## FIELD INSPECTION

<b>Project Name:</b>	Mountain Valley Pipeline	<b>Inspector:</b>	Matthew Grant
<b>Inspection Date:</b>	Wednesday, November 28, 2018	<b>Project Contact:</b>	Brian Clauto
<b>Spread: Giles County AR GI 234 Designated stream SQ14</b>	Spread G	<b>Weather (Wet/Dry/Rain):</b>	Wet

## FIELD INSPECTION PHOTO LOG

Fig. 1 AR GI 234 rock lined channel

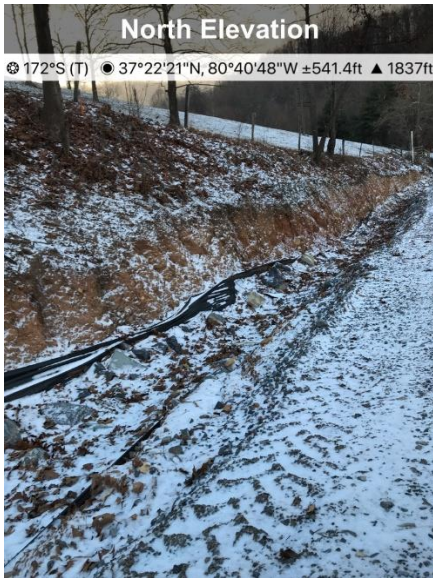
- Access Road GI 234 rock lined channel appears to be functioning; vertical cut ditch walls are not stabilized. Designated stream SQ14 shows signs of sediment and possibly road gravel in the stream.

**Recommended Corrective Action:** Submit amended plans for GI 234 access road to DEQ for approval; remove sediment and road gravel on SQ 14 per property owner approval.
